APPLICATION FOR MODIFICATION ASSESSMENT REPORT

Application Number:	Mod2021/0509
----------------------------	--------------

Responsible Officer:	Clare Costanzo
Land to be developed (Address):	Lot 20 DP 758044, 1 Tabalum Road BALGOWLAH HEIGHTS NSW 2093
Proposed Development:	Modification of Development Consent DA2020/0077 granted for demolition works and construction of a dwelling house
Zoning:	Manly LEP2013 - Land zoned R2 Low Density Residential
Development Permissible:	Yes
Existing Use Rights:	No
Consent Authority:	Northern Beaches Council
Land and Environment Court Action:	No
Owner:	Kevin Scott Mooney
Applicant:	Kevin Scott Mooney

Figure 1: View looking south west from adjoining dwelling at 3 Tabalum Road, Balgowlah Heights

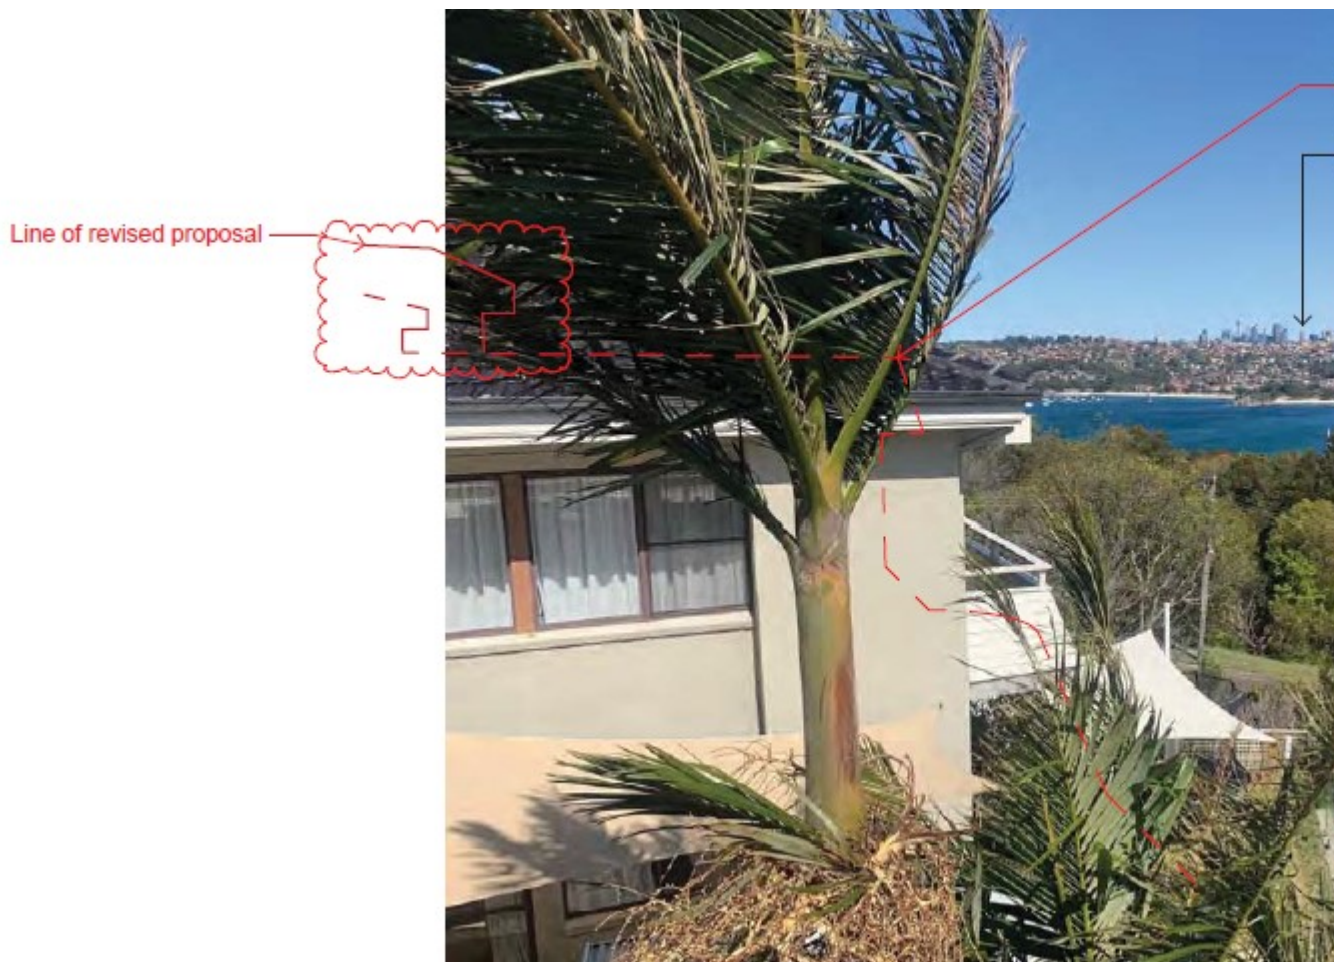
Views towards Middle Harbour and the City skyline are obtained from the western balcony of the adjoining dwelling. These views are enjoyed from a standing and a sitting position. The proposed clerestory extension will not obstruct the south western views available.

The proposed clerestory extension is considered to have a negligible impact on the view enjoyed by the adjoining dwelling. Expansive views towards Middle Harbour and the City skyline will remain available as shown in Figure 1 and 2 below.

The extension to the approved clerestory is not expected to result in any unreasonable impacts and the view loss is considered negligible given the retention of water views towards Middle Harbour and the City skyline remain available for the adjoining dwelling at 3 Tabalum Road.
